ADDENDUM NO. 04

PROJECT: BRADFORD CSD - 2023 CAPITAL IMPROVEMENT PROJECT

DATE: 04/04/2025

1 NEW WORK ROOF PLAN
 1/8" = 1'-0"

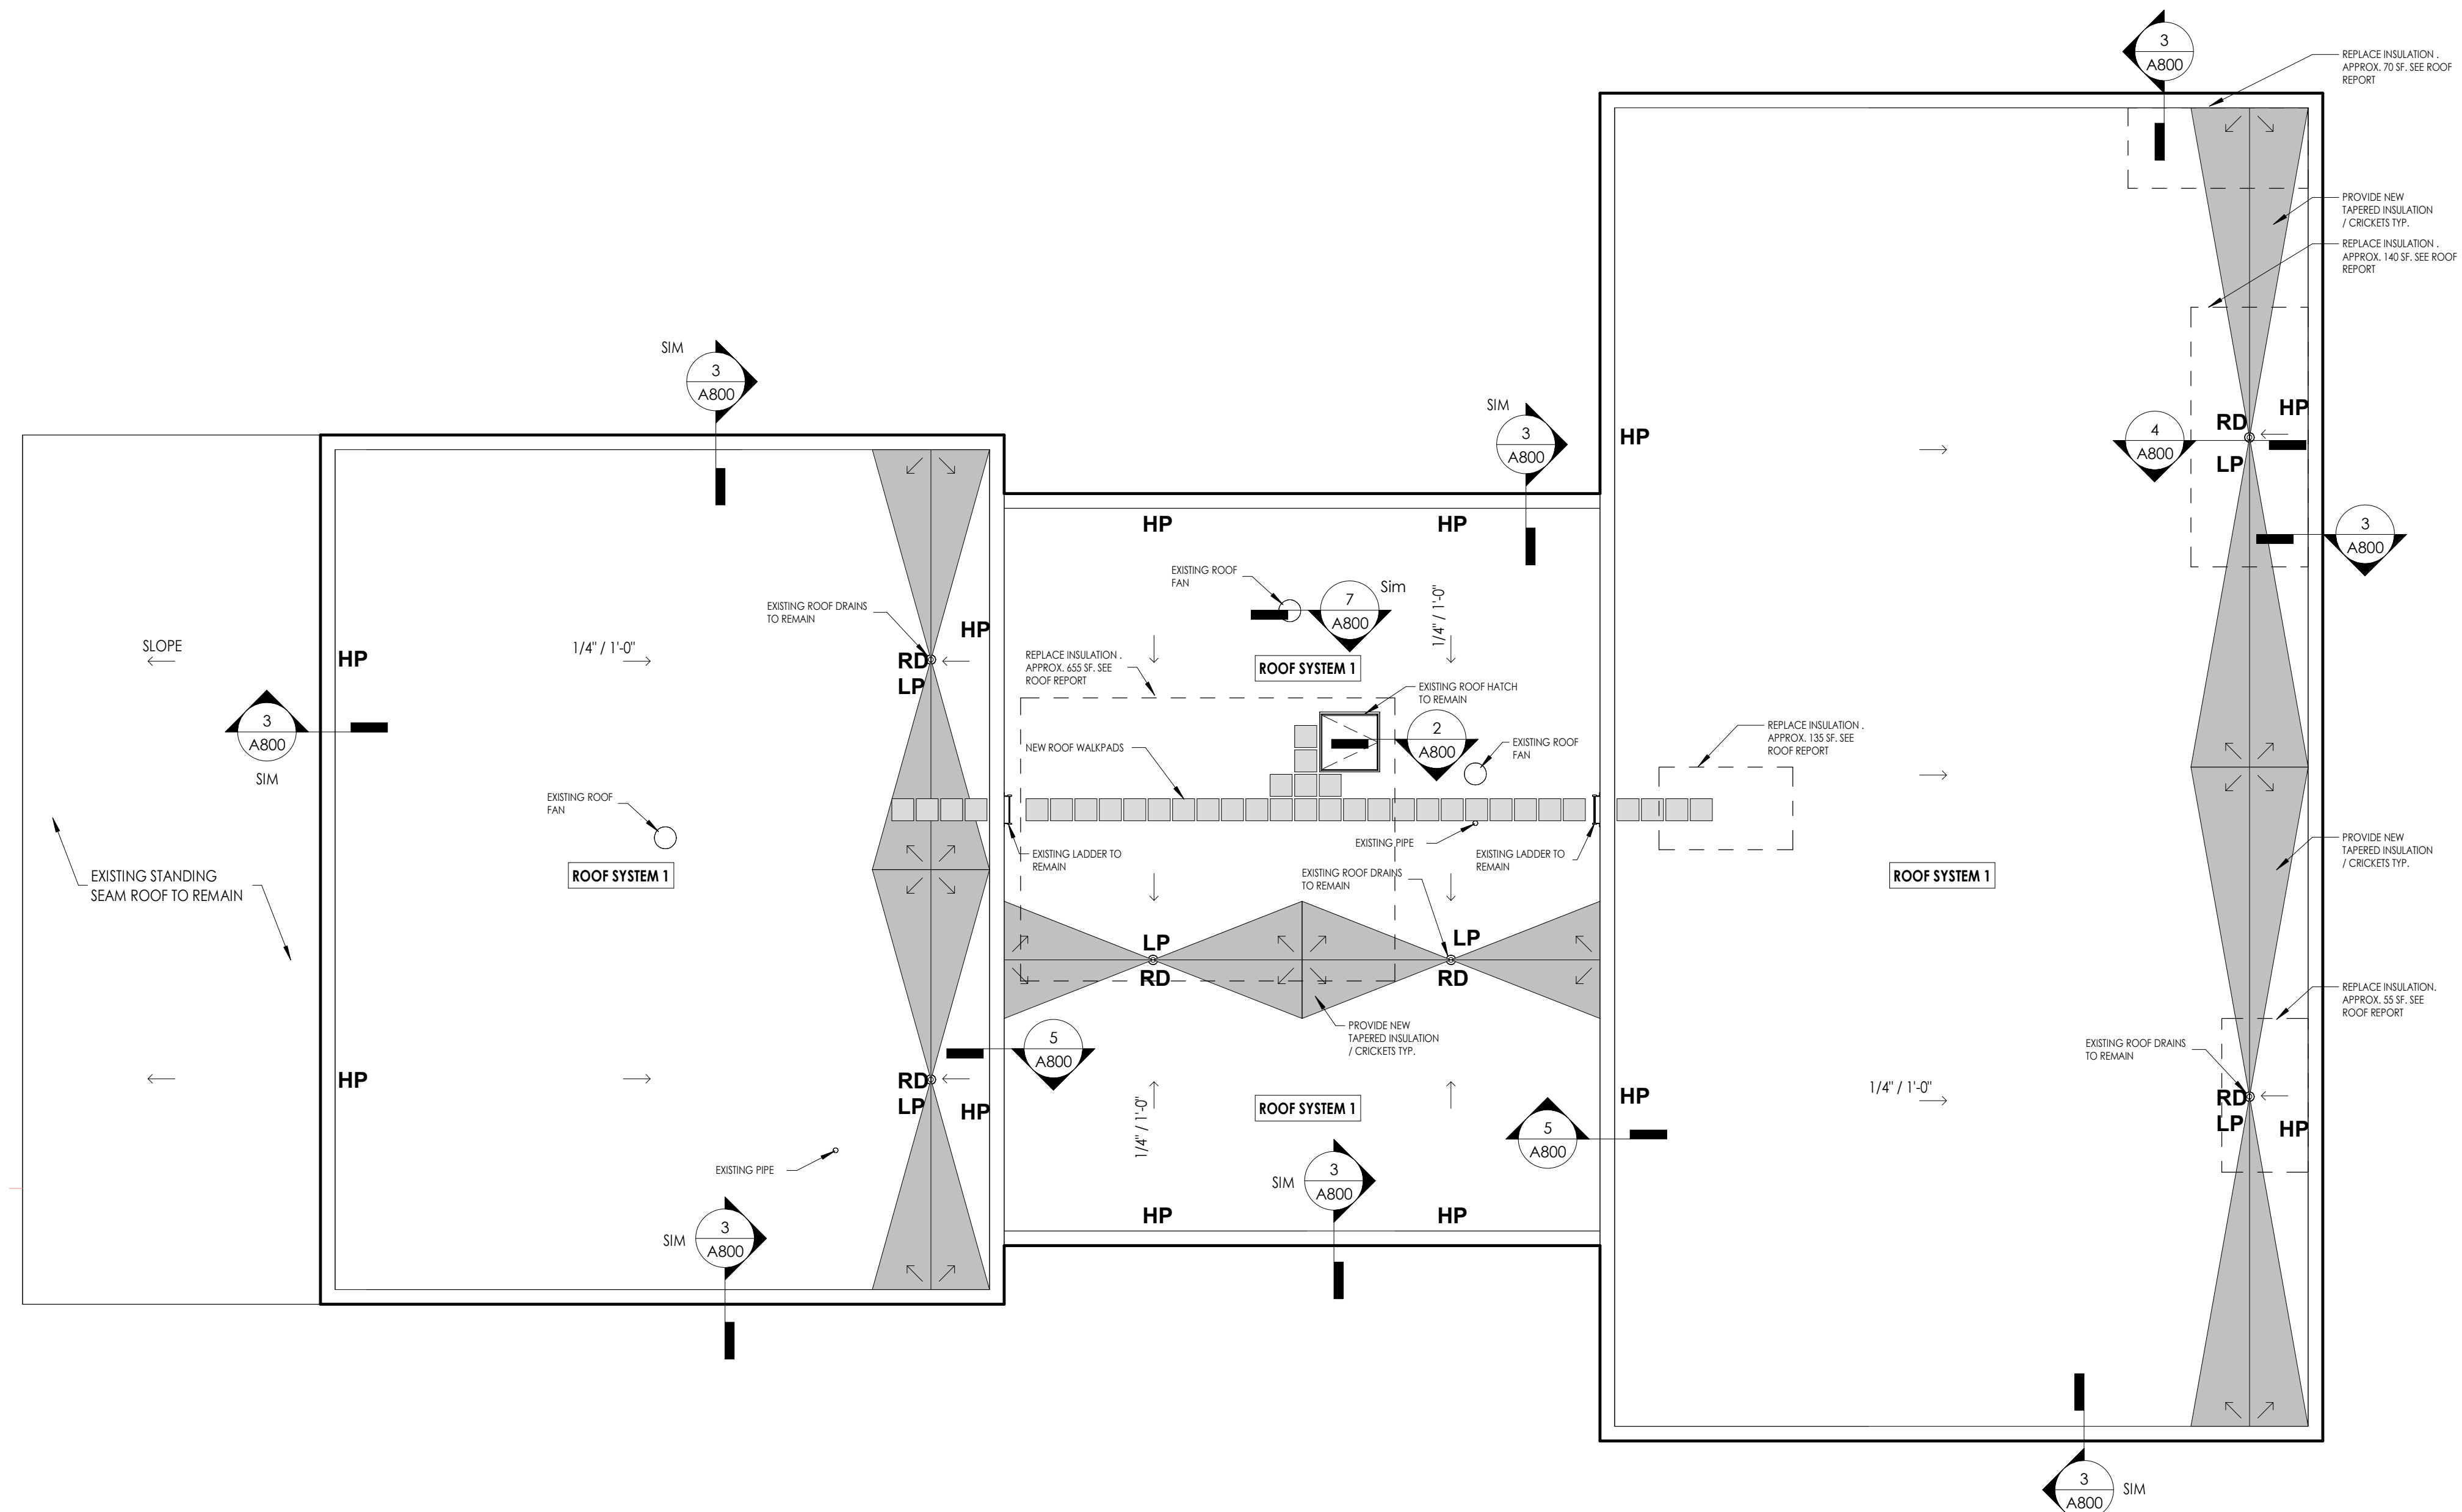
QUESTION: Please clarify the scopes of work for the GC and MC as it pertains to the roof work required for installation of equipment curbs, rails, and pipe portals. Currently shown and noted on MB A-202 & 800 and on MB H-202.1, 202.2, 202.3, 202.4, H302.1, 302.2, 302.3, 302.4

| MB-A202 | REVISE GENERAL NOTES TO CLARIFY CONTRACTOR SCOPE OF WORK. |

- REFER TO MULTIPLE CONTRACT SUMMARY FOR DELINEATION OF CONTRACTOR SCOPE AND RESPONSIBILITY FOR ROOF WORK.
- THE INSTALLED ROOFING SYSTEM SHALL MEET ALL REQUIREMENTS FOR CLASSIFICATION AS "A" IN CLASS "A" ROOF ASSEMBLY.

1 BUS GARAGE DEMOLITION PLUMBING WORK PLAN
 P101 3/16" = 1'-0"

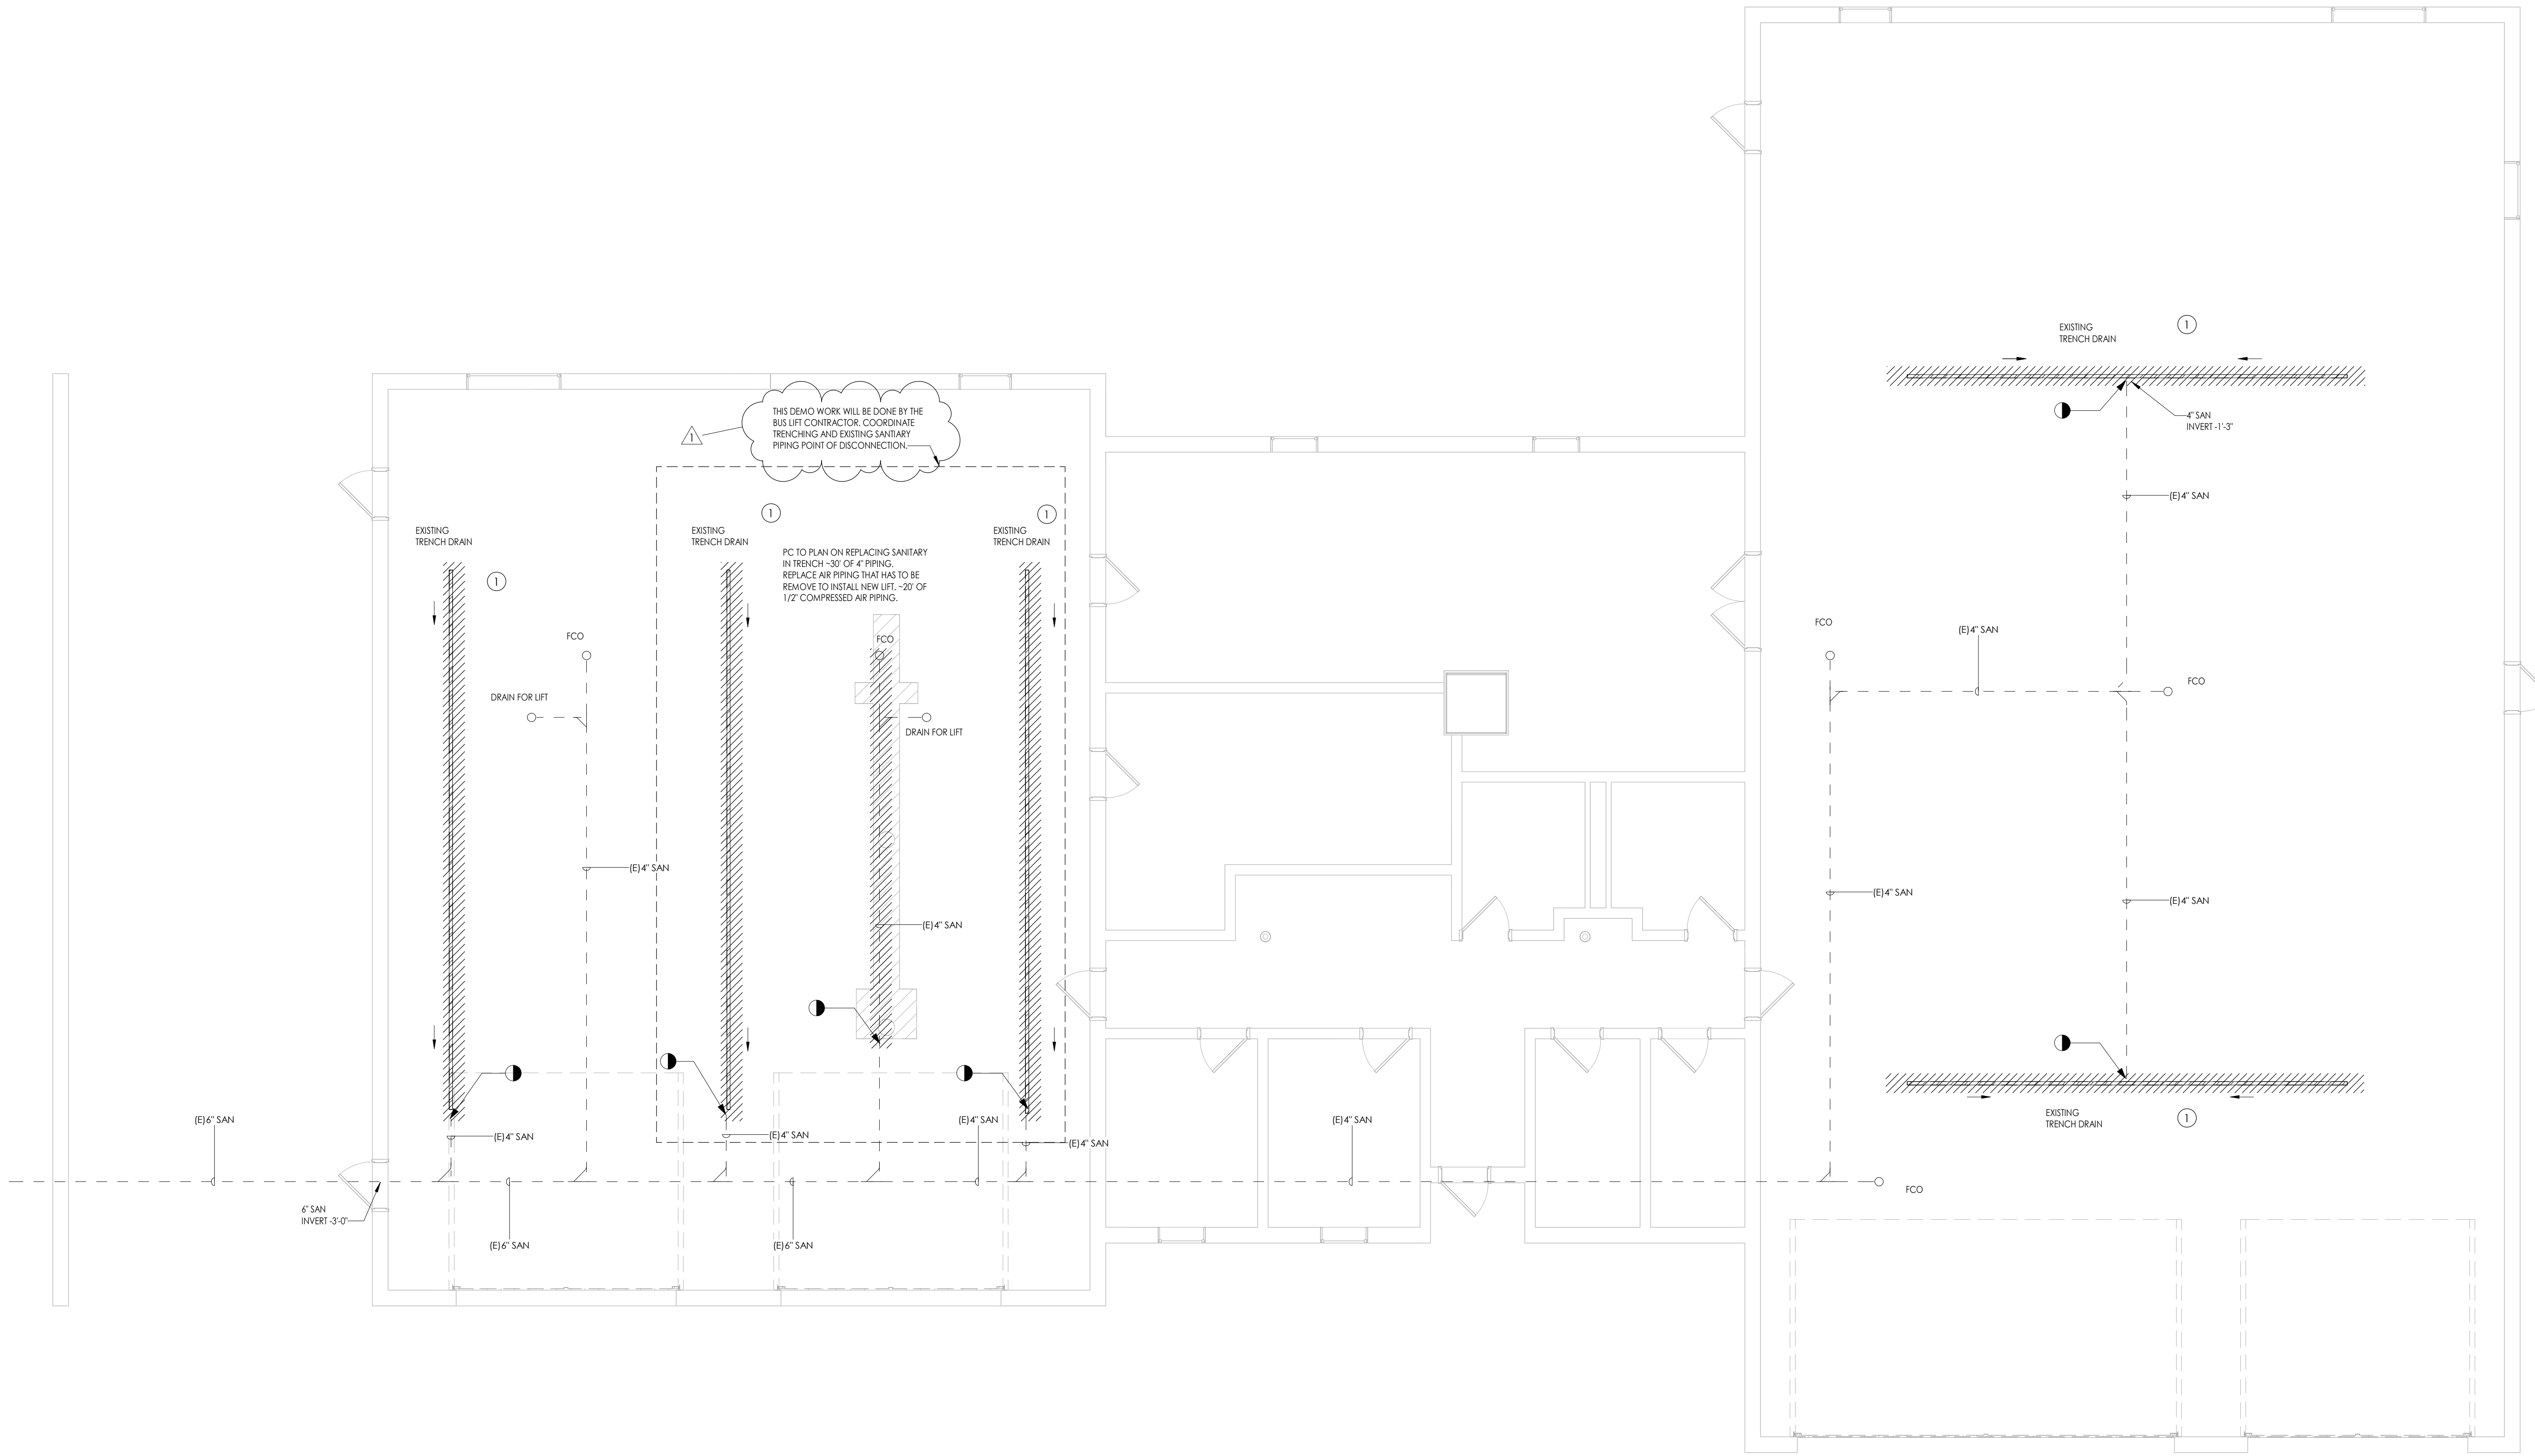
| BG-P101 | REMOVED/EDIT COMMENTS TO CLARIFY CONTRACTOR SCOPE OF WORK. |

- ① TRENCH DRAINS TO BE REMOVED AS PART OF THE GC SLAB REMOVAL. PC TO COORDINATE SANITARY PIPING DURING DEMO AND FOR NEW CONNECTIONS.

1 BUS GARAGE NEW PLUMBING WORK PLAN
P201 3/16" = 1'-0"

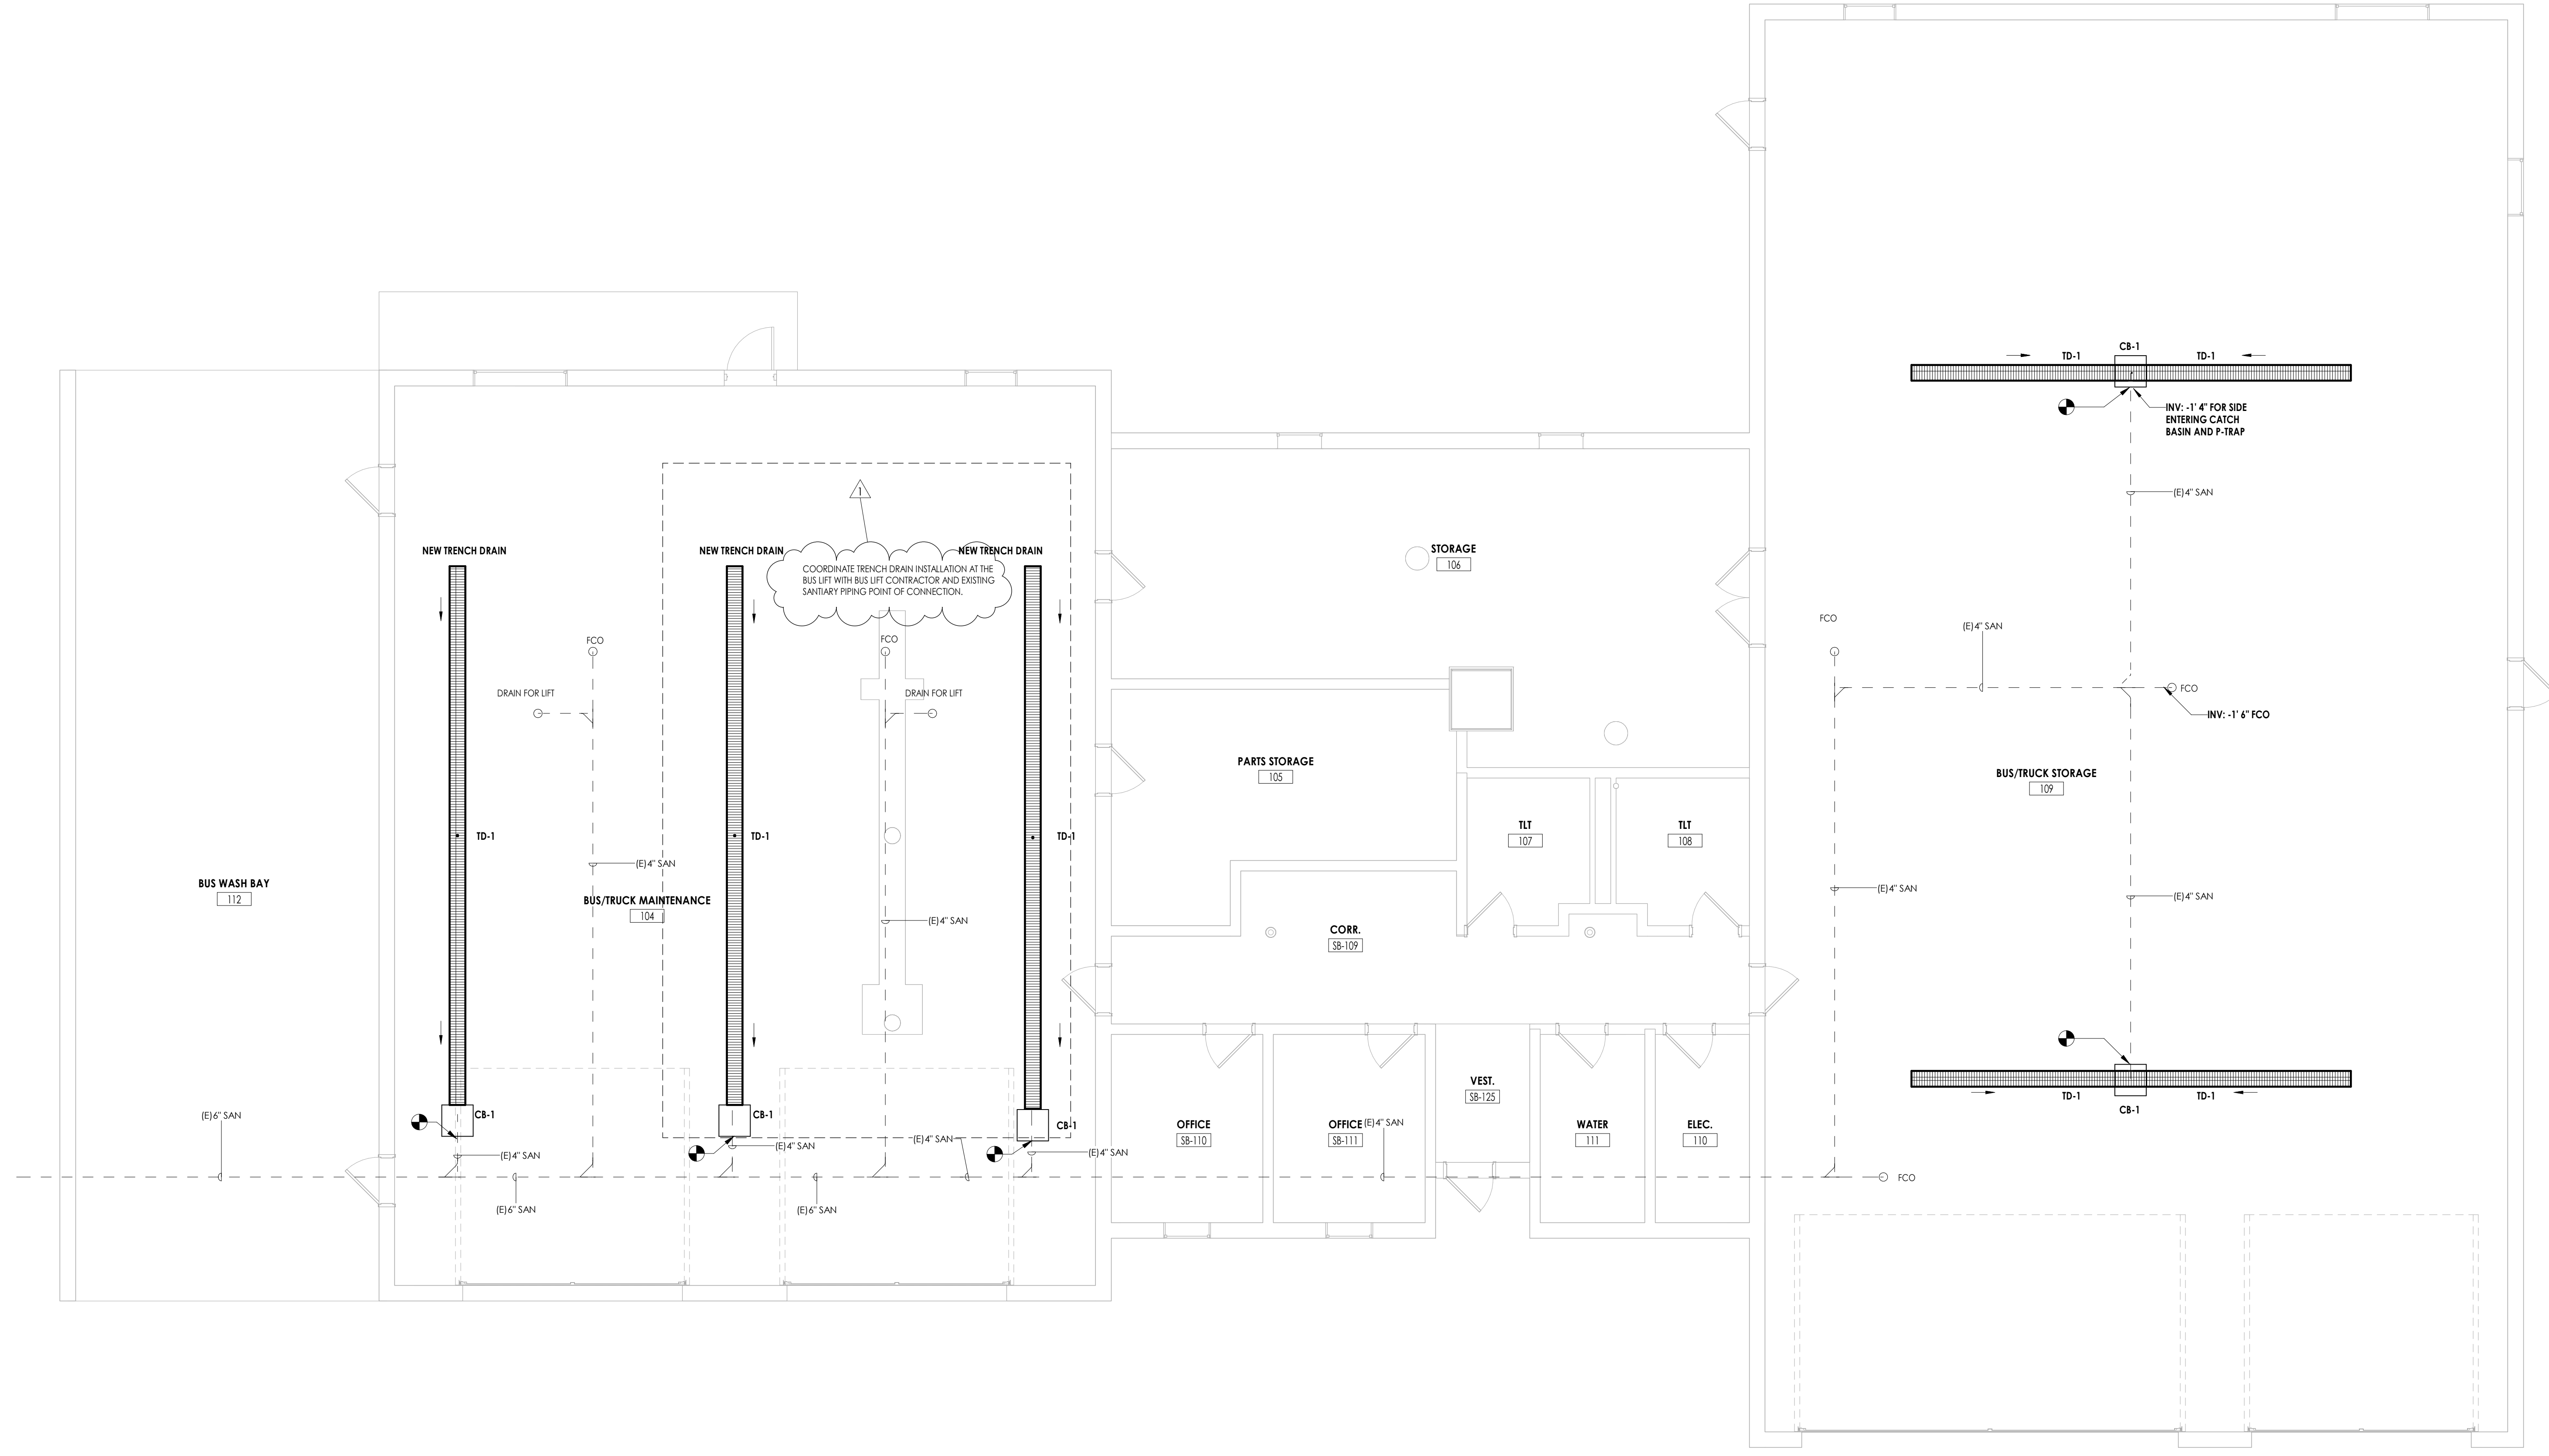
| BG-P201 | REMOVED/EDIT COMMENTS TO CLARIFY CONTRACTOR SCOPE OF WORK. |
